File No. F-01-122
Willet's property

**DEPARTMENT OF PLANNING AND ZONING
FINAL PLAT ORIGINAL FOR SIGNATURE APPROVAL**

RE: Septic System Abandonment
Percolation Application #510157
Property ID: Wilet Property -
Long Corner Road
Tax Map: 6 Block: 21 Parcel: 55

RE: Percolation Test Results
Application # A510157
Willetts Property
Long Corner Road
Proposed use: Subdivision

F-01-122
2/27/01
Revised Final
Driveway Easement
Changes

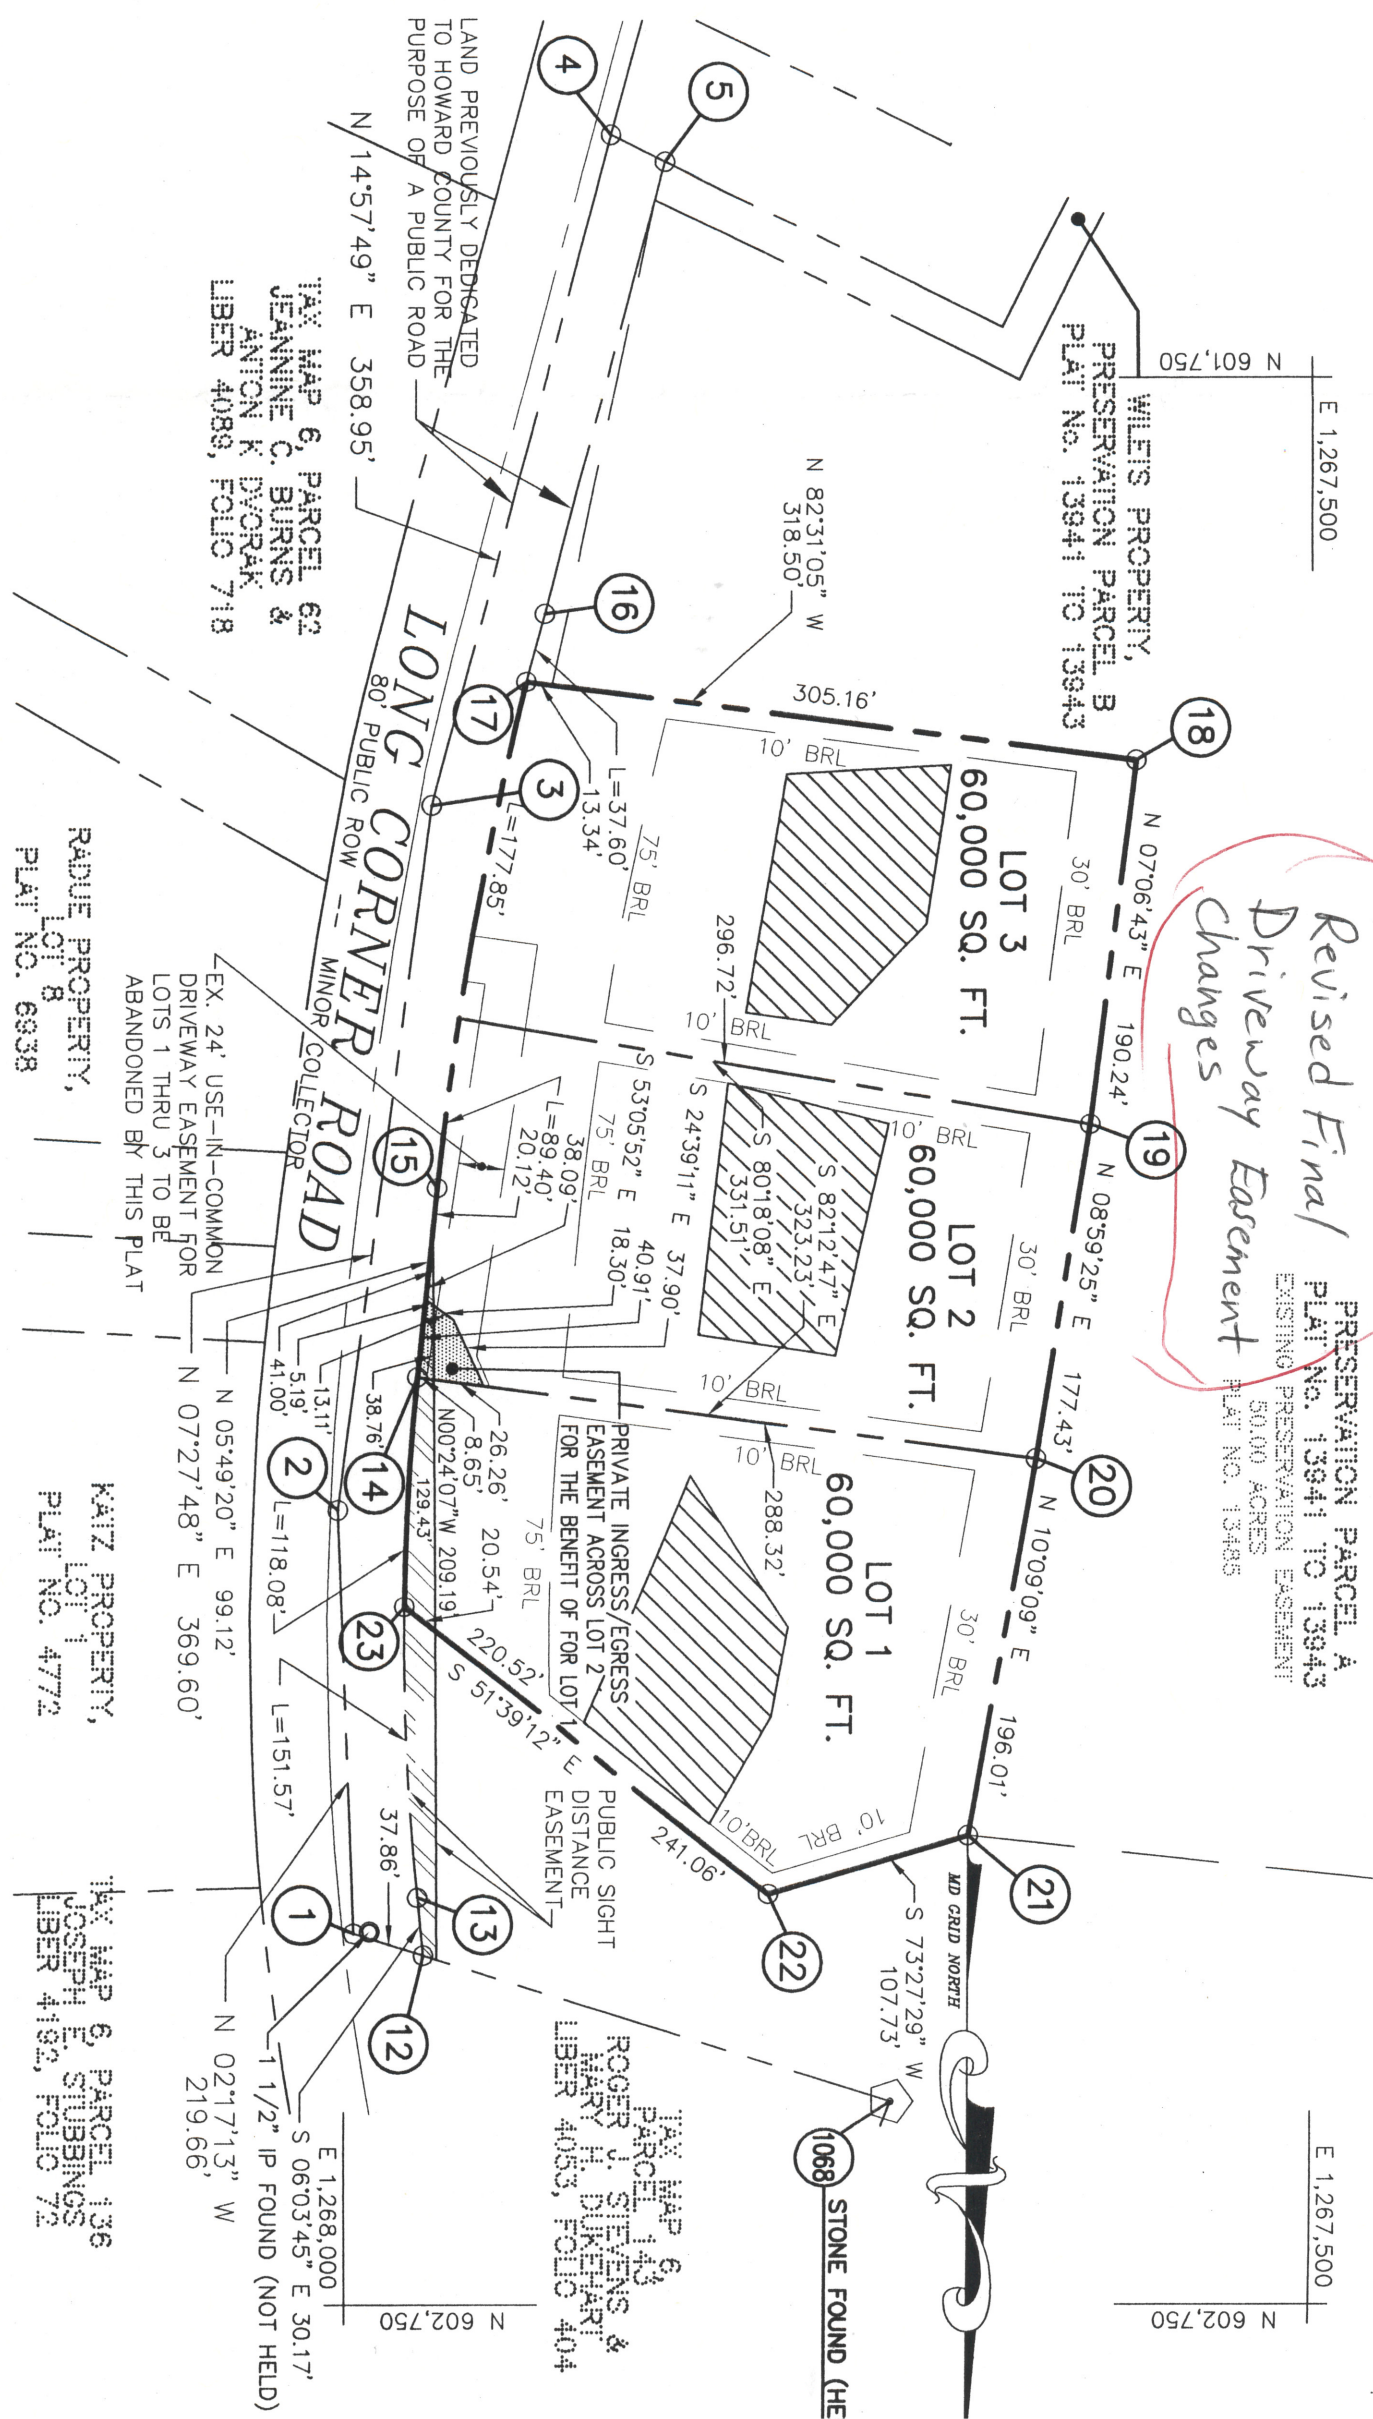
EX. 24' USE-IN-COMMON
DRIVEWAY EASEMENT FOR
LOTS 1 THRU 3 TO BE
ABANDONED BY THIS PLAT

LOCATION DIAGRAM

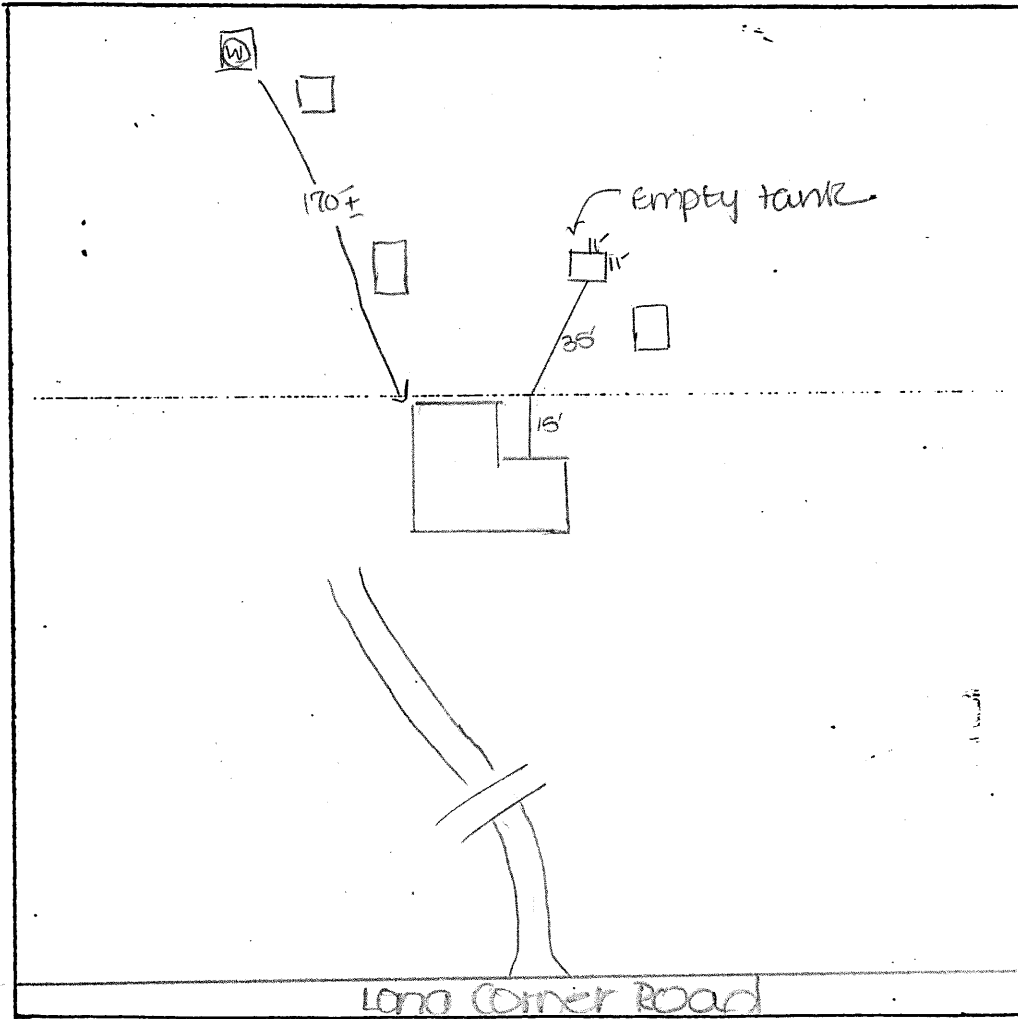
COMMENTS: Drilled well in pit/ small well house previously abandoned
Terra cotta sewer line exiting house cut at house -
6' deep, 11' square cinder block tank empty - filled w/
clean fill. No outlet pipe.

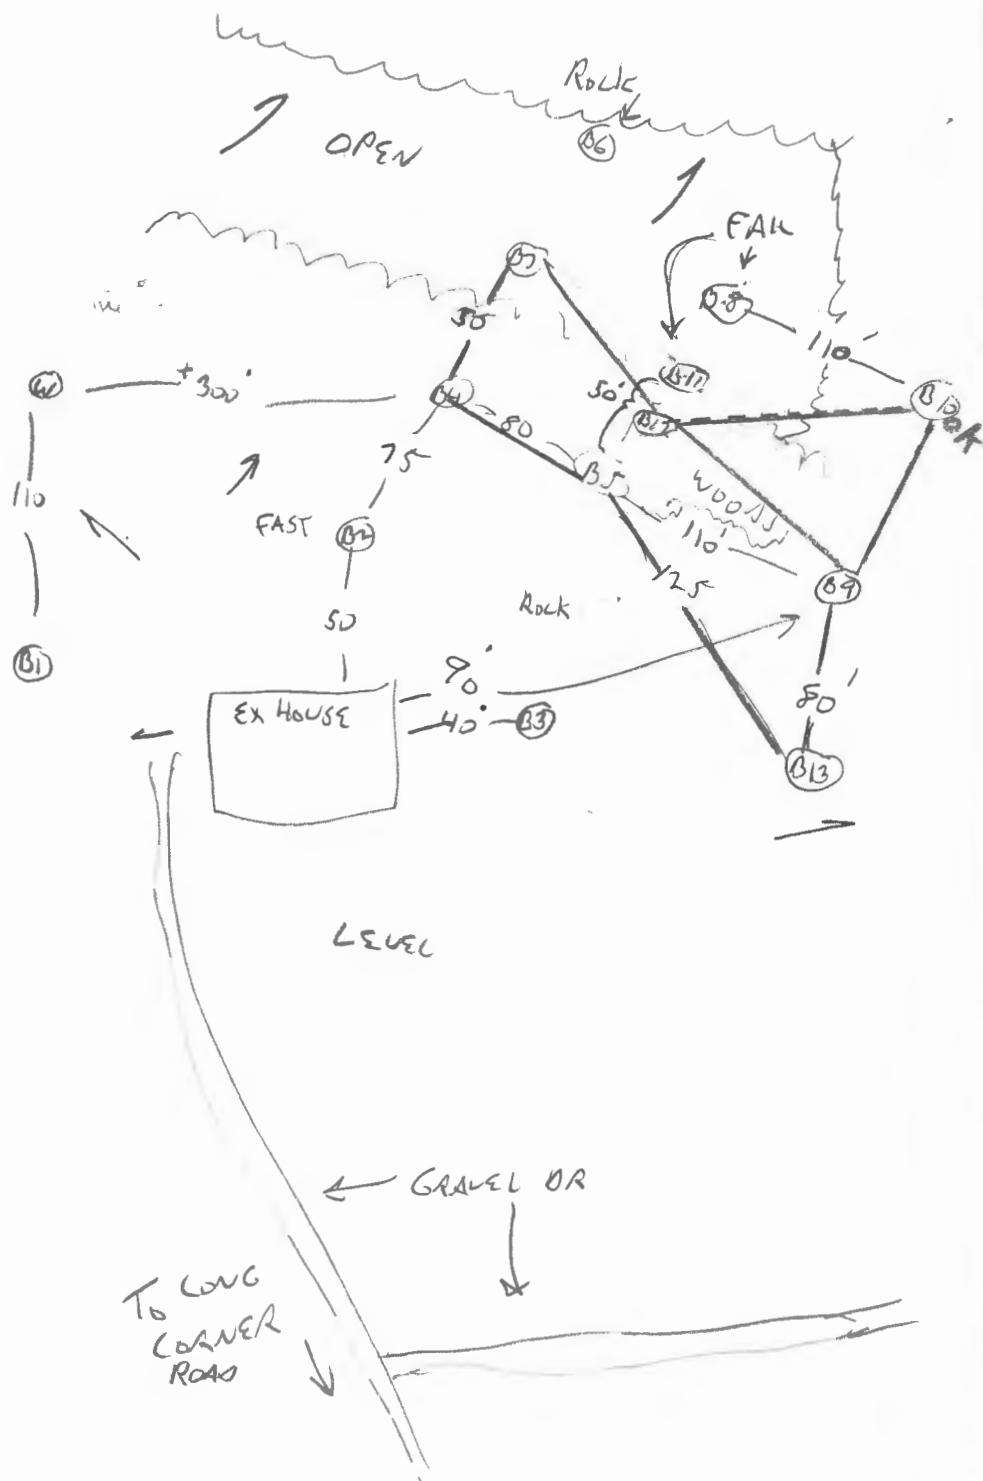
USE: B4 B5, B13 FOR HIGH HOLES

B10, B7, B12, B9 FOR LOW HOLES

REASONABLY GOOD MATCH TO CONTOUR

TEST HOLES TO BE
FIELD LOCATED

LOCATION DIAGRAM

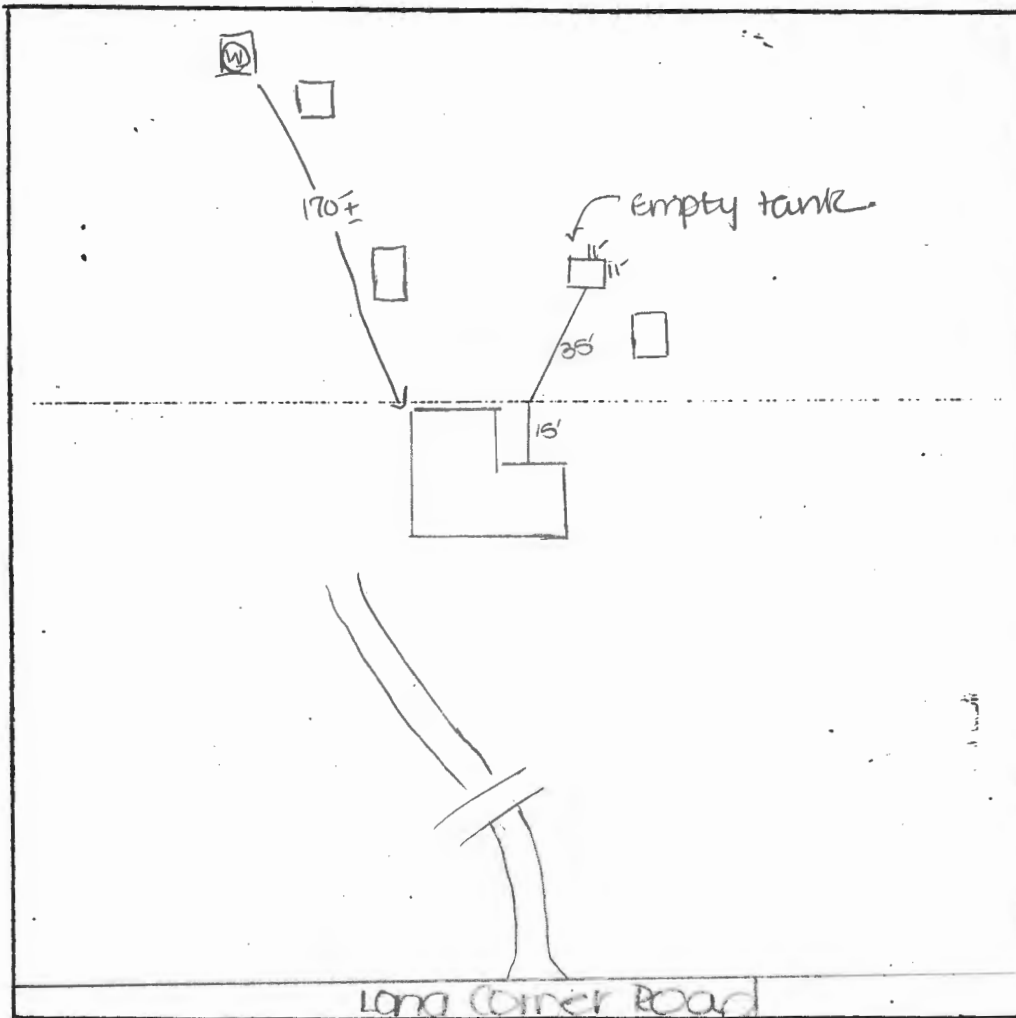
COMMENTS: Drilled well in pit/ small well house previously abandoned.
Terra cotta sewer line exiting house cut at house -
6' deep, 11' square cinder block tank empty - filled w/
clean fill. No outlet pipe.
